INDESIT company

Model type:
ARSF109EU

Commercial code:
F054420

n4008f00: Thermic link wire removed on three-phase motor

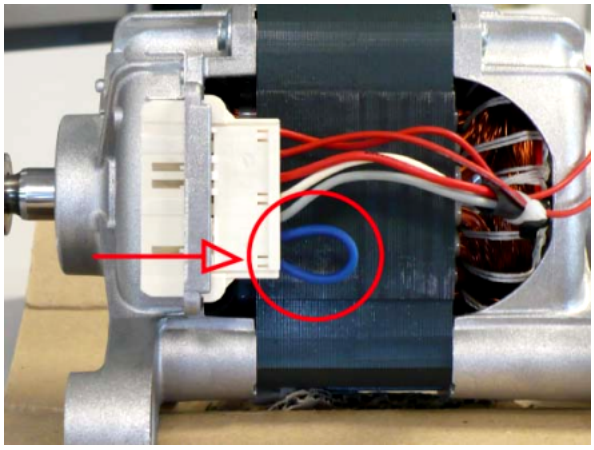
When you assist the premodification models using the new motor code you MUST use the thermic link wire code C00265838.

The spare part warehouses will manage the premodification motor until the end of the stock, after they will be replaced with new ones and thermic link wire.

TRIPHASE P40 46 L – PLASTIC TUB
C00265826 new motor without thermic link wire - C00142390 premodification motor with thermic link wire

In the attached image you can see the fixing of thermic link wire in the motor therminal box.
